NEW ELEMENTARY AND MIDDLE SCHOOL

CONTENTS - VOLUME TWO

phase	Bid Package No. 2
date	January 3, 2008
ADD	October 17, 2007
ADD	October 26, 2007
ADD	November 2, 2007
ADD	November 5, 2007

project # 06022

project # | 06022
Lighting Plan
Sector "G"

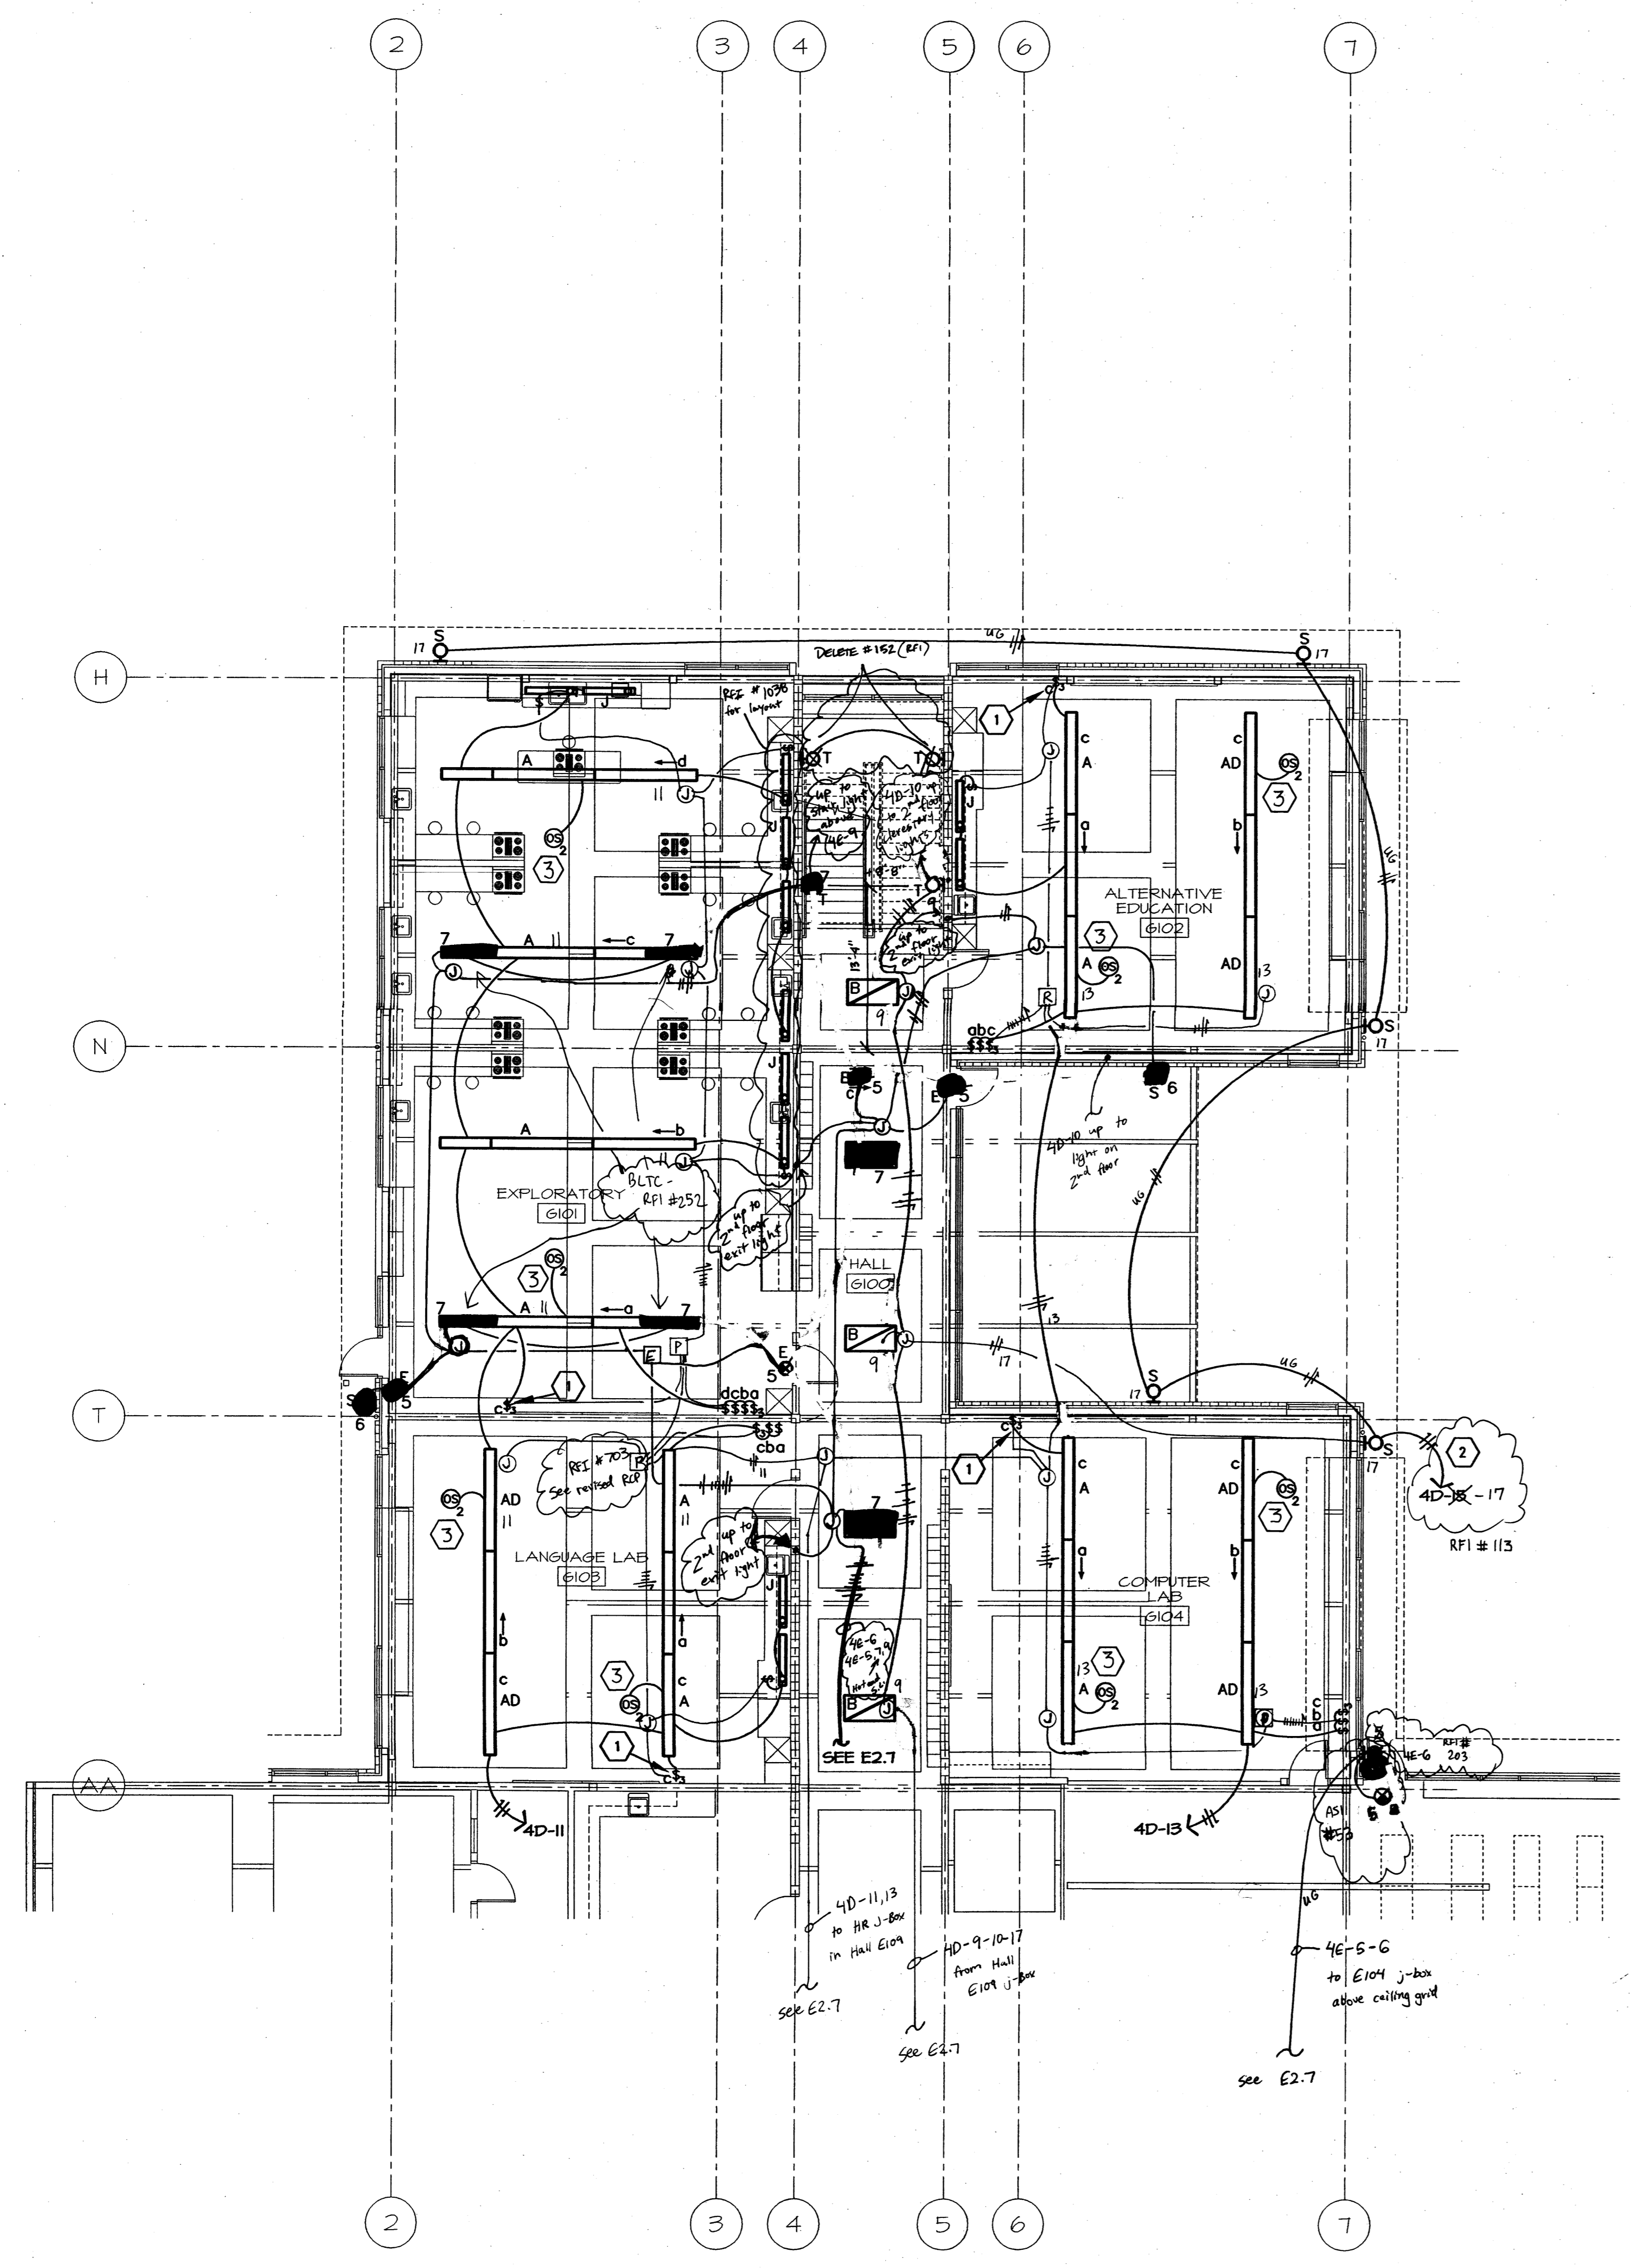
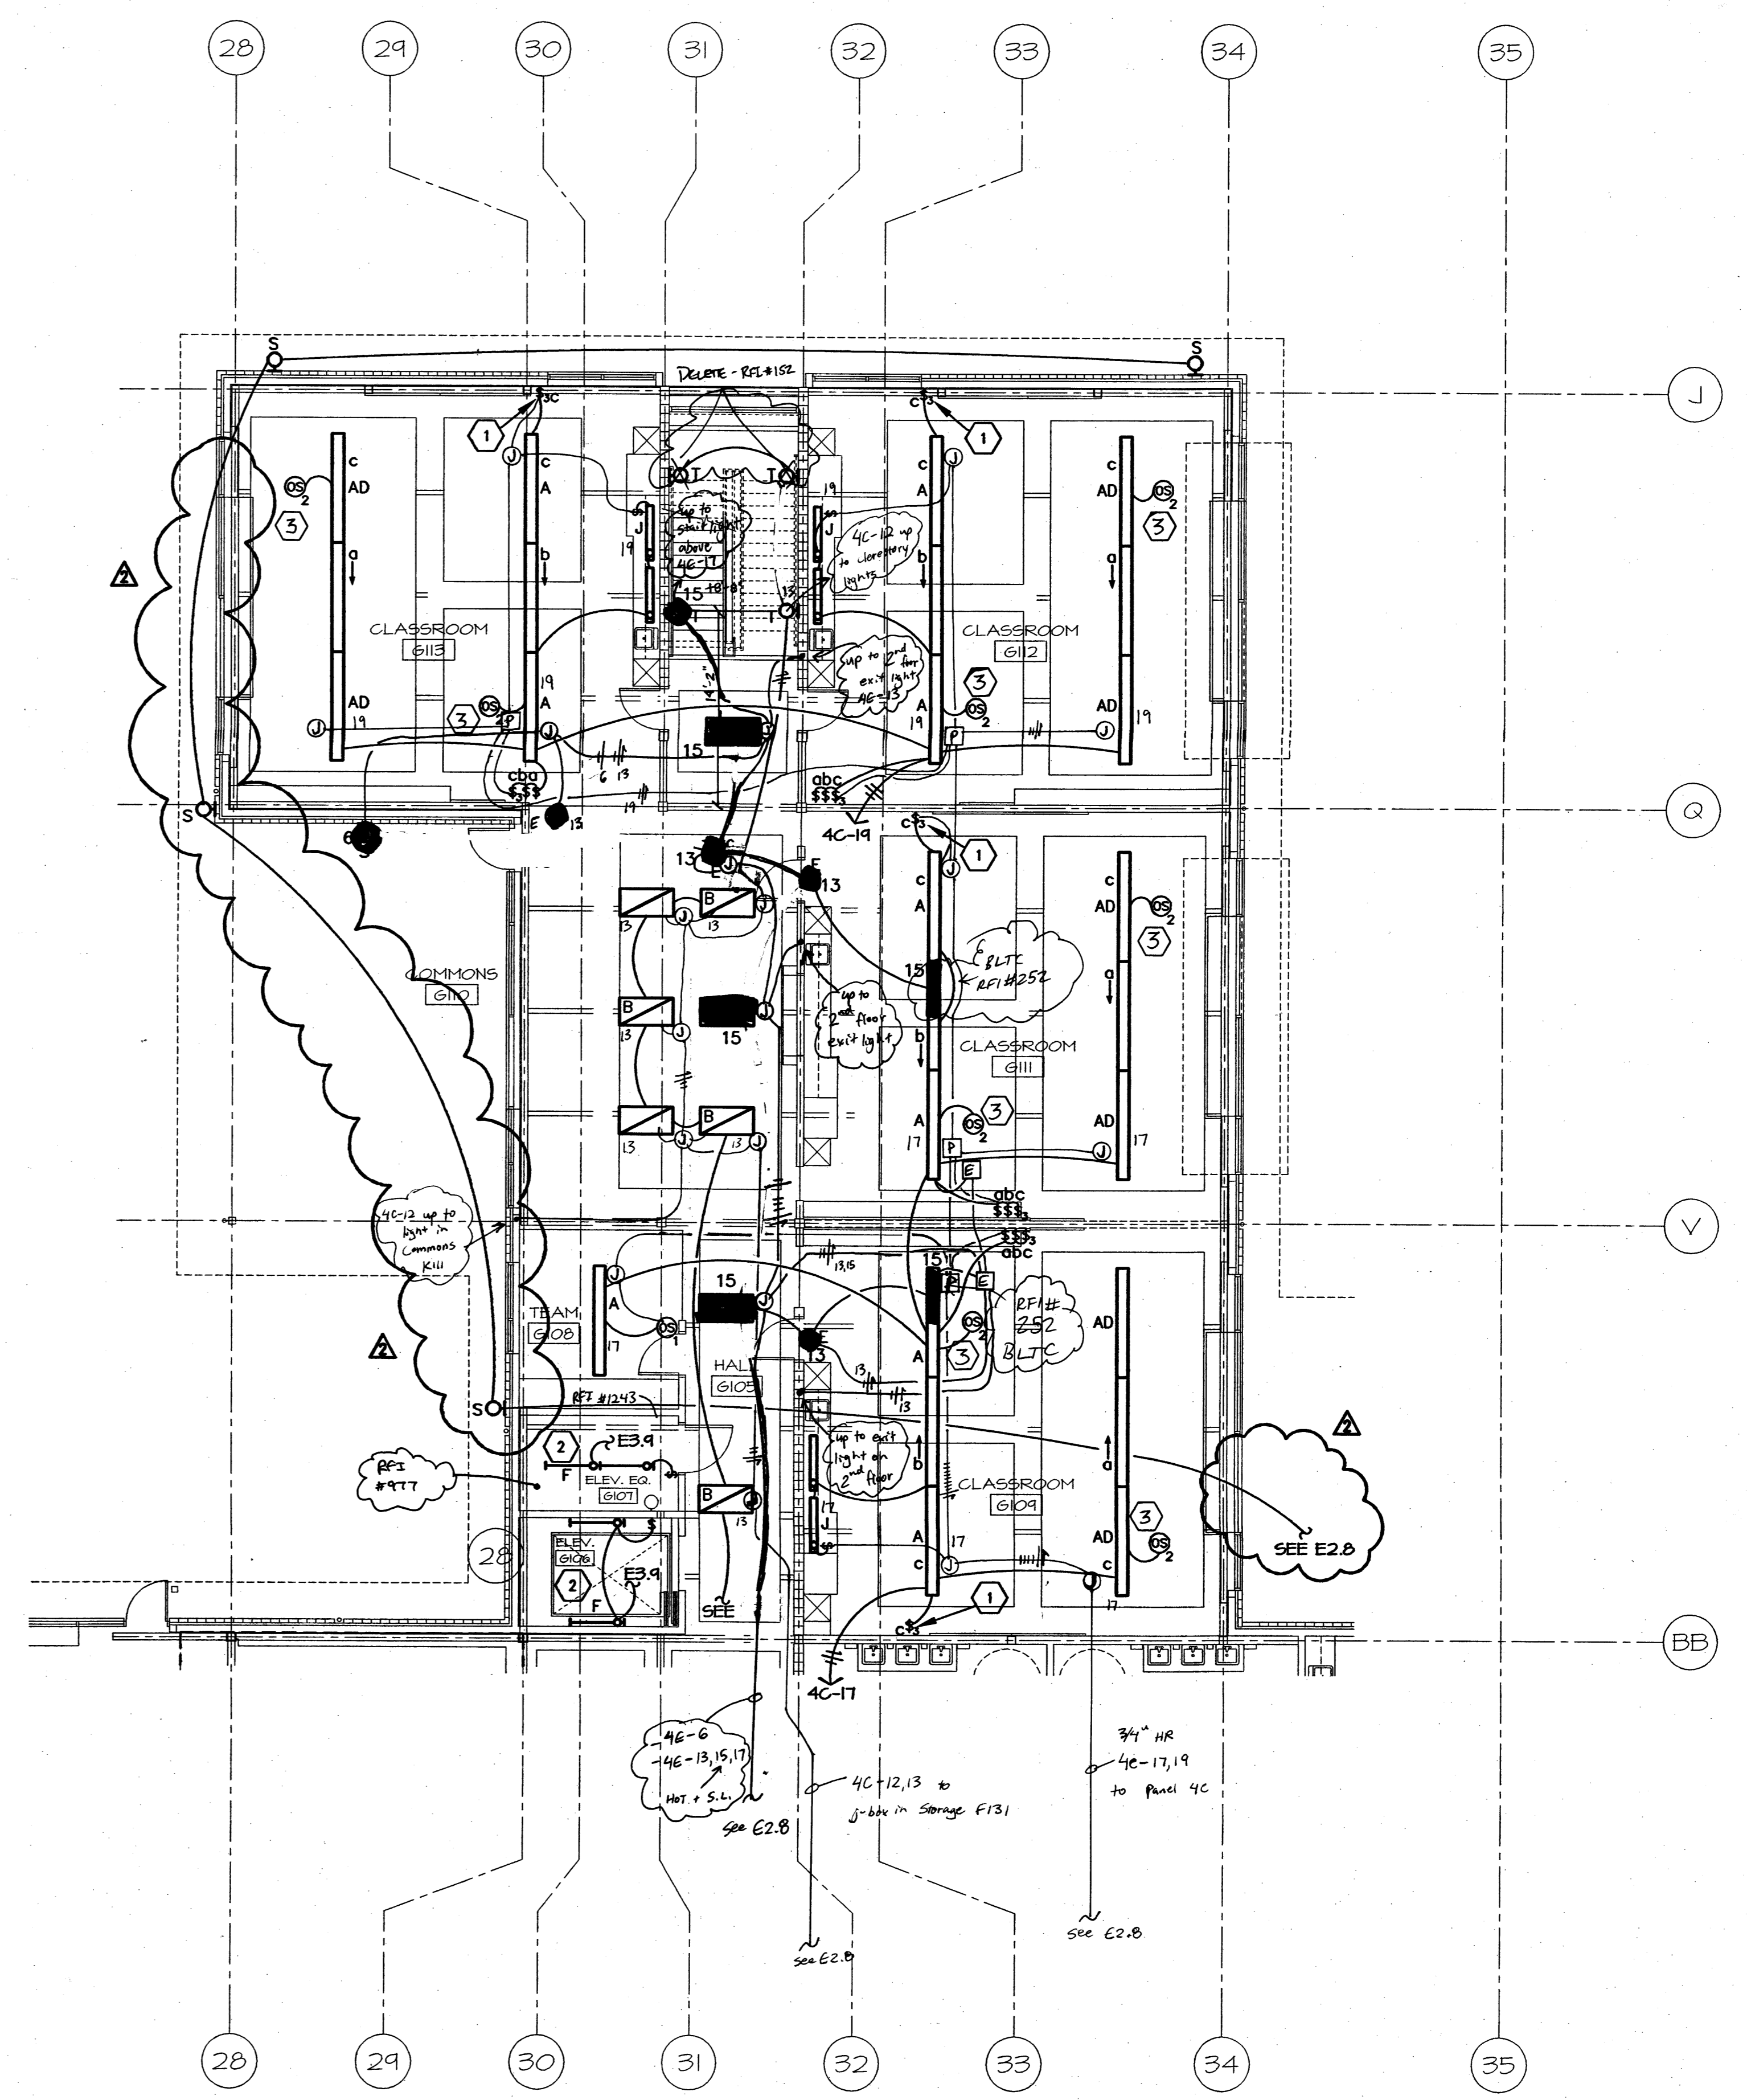
PLAN NOTES
RFI # 113
2 To Designated Panel via 'LCP-D' Leg control Panel

PLAN NOTES
1 SWITCH TO BE LOCATED ADJACENT TO WHITE BOARD. COORDINATE EXACT LOCATION WITH ARCHITECT PRIOR TO ROUGH-IN. TYPICAL IN CLASSROOMS.
2 TYPE 'D' FIXTURES IN ELEVATOR PIT AND MACHINE ROOM TO OPERATE AT 120V.
3 TYPE 'Z' OCCUPANCY SENSORS WORKING IN TANDEM IN NOTED ROOMS Per RFI # 362

See RFI # 894 for TNEK penetrations

POWER PLAN - SECTOR "J"
 SCALE: 1/8" = 1'-0"

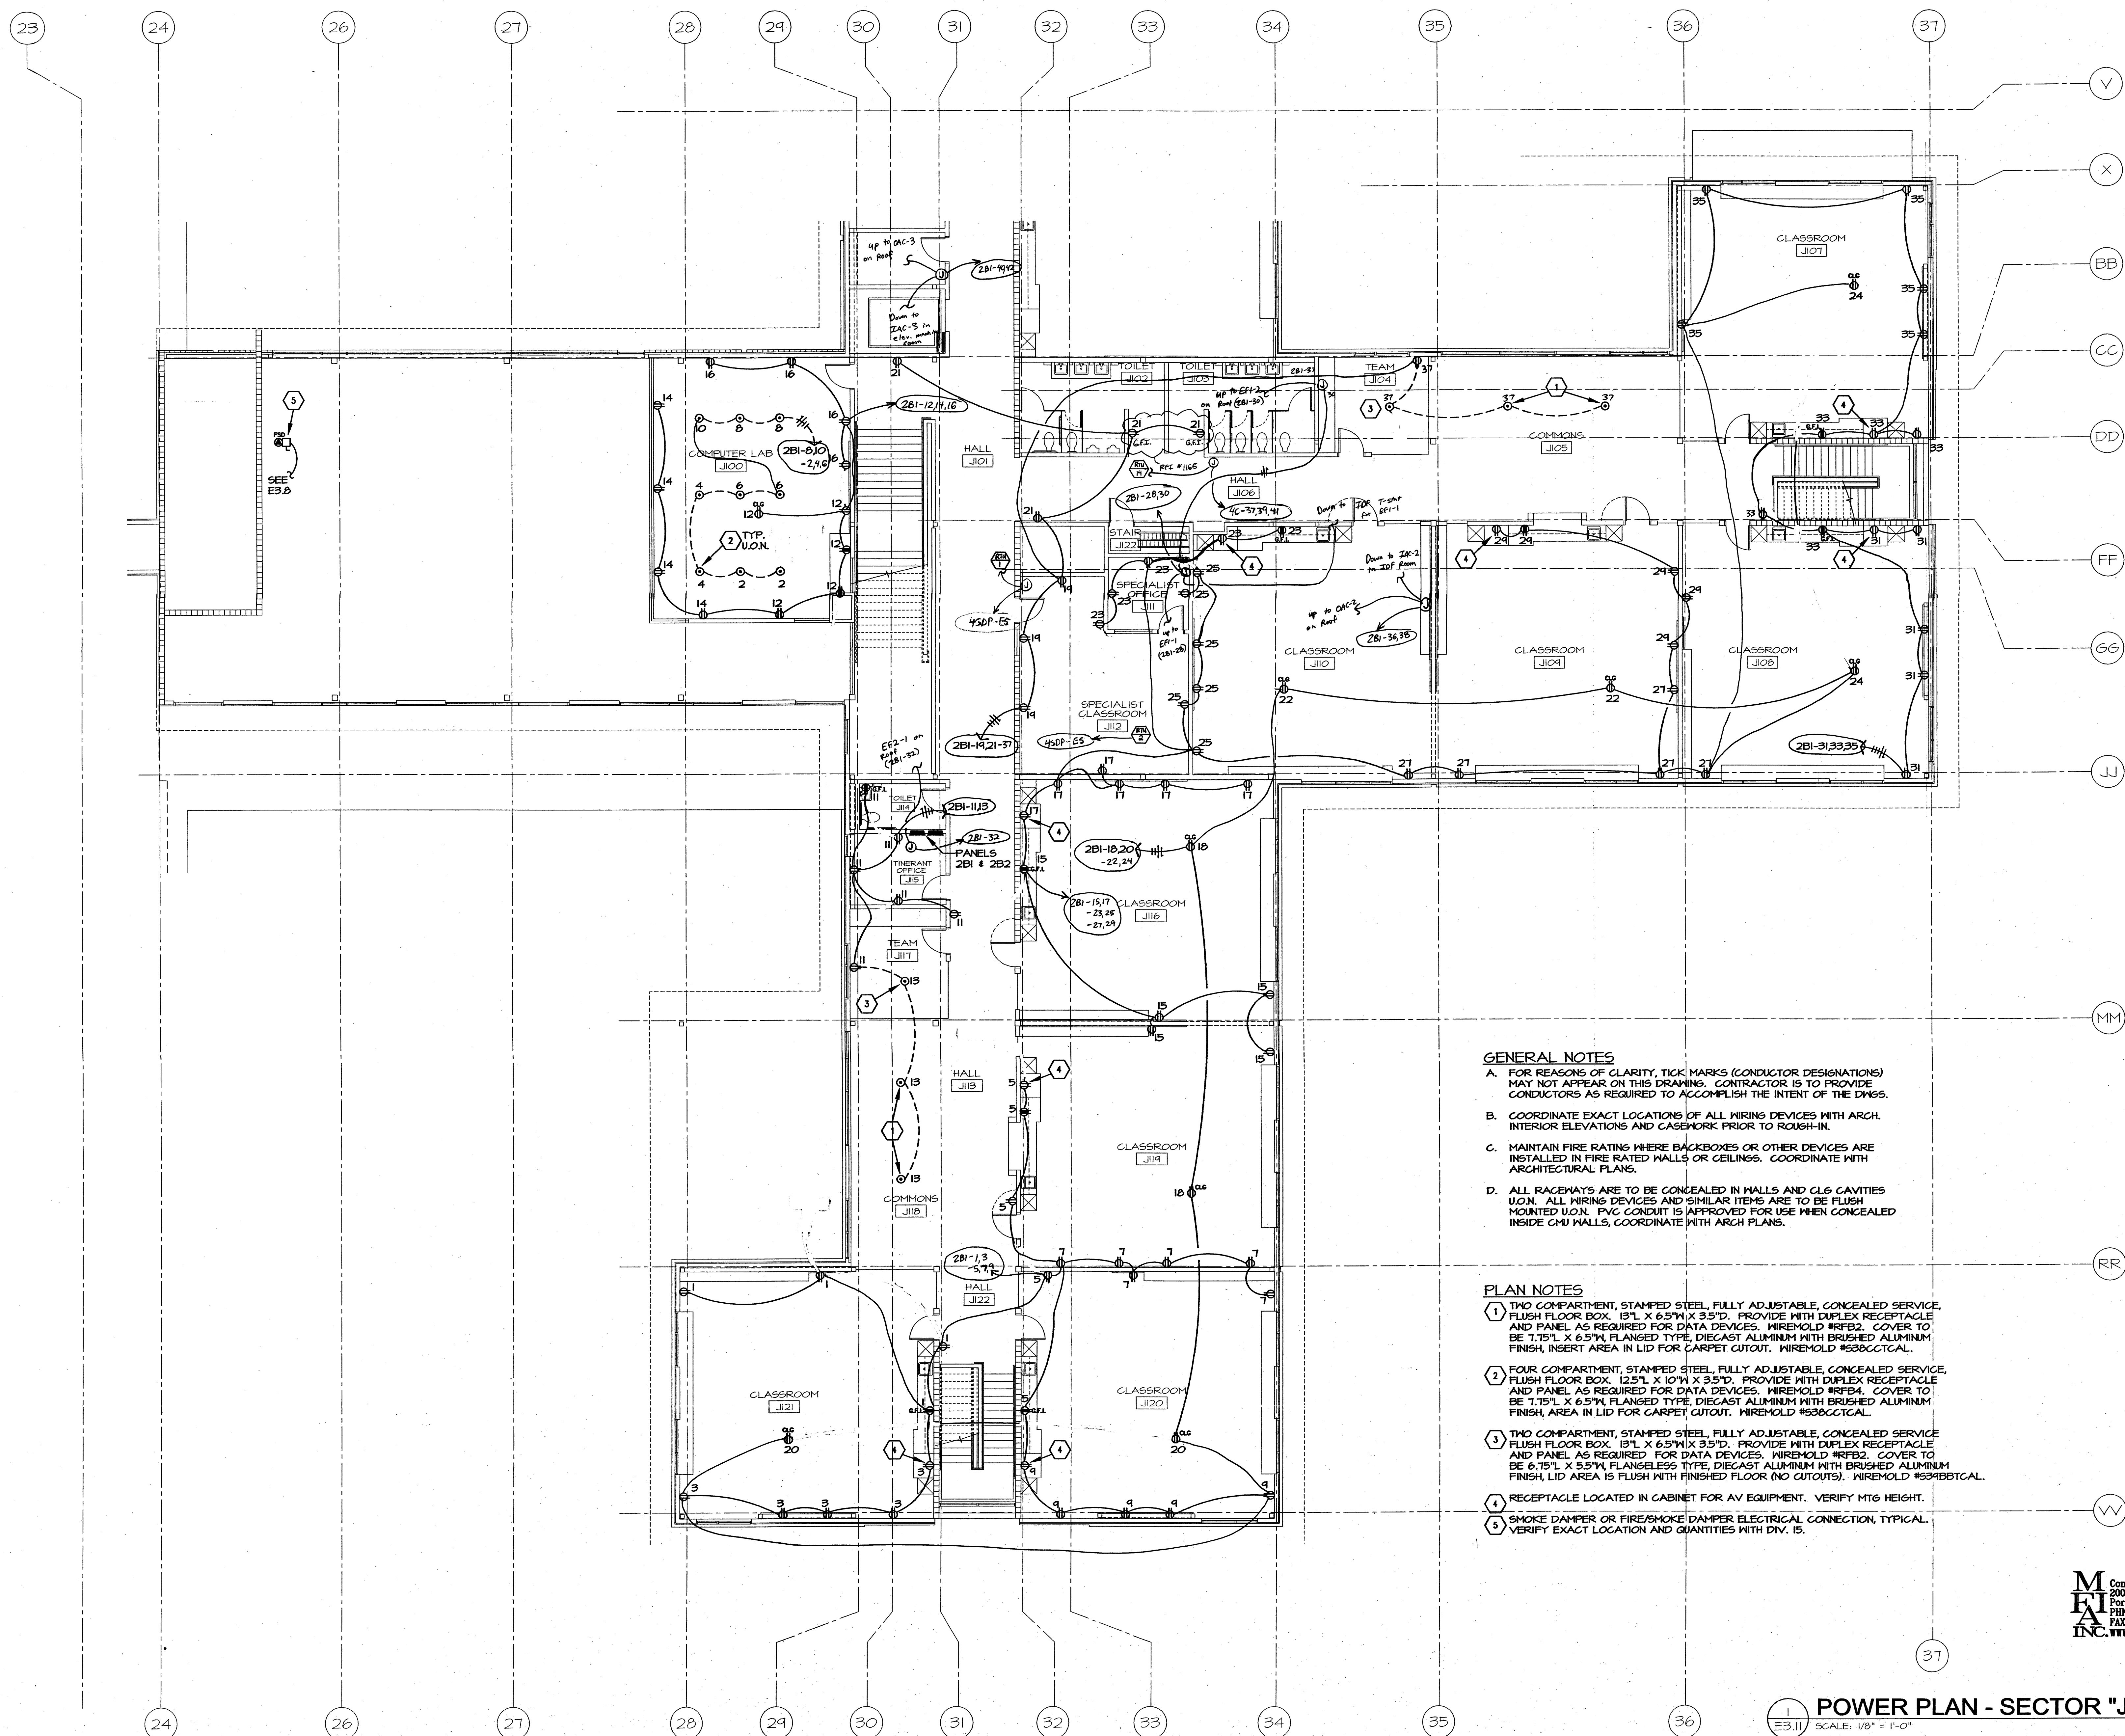
GRID LINES ARE NOT CORRECT ON THIS PAGE!
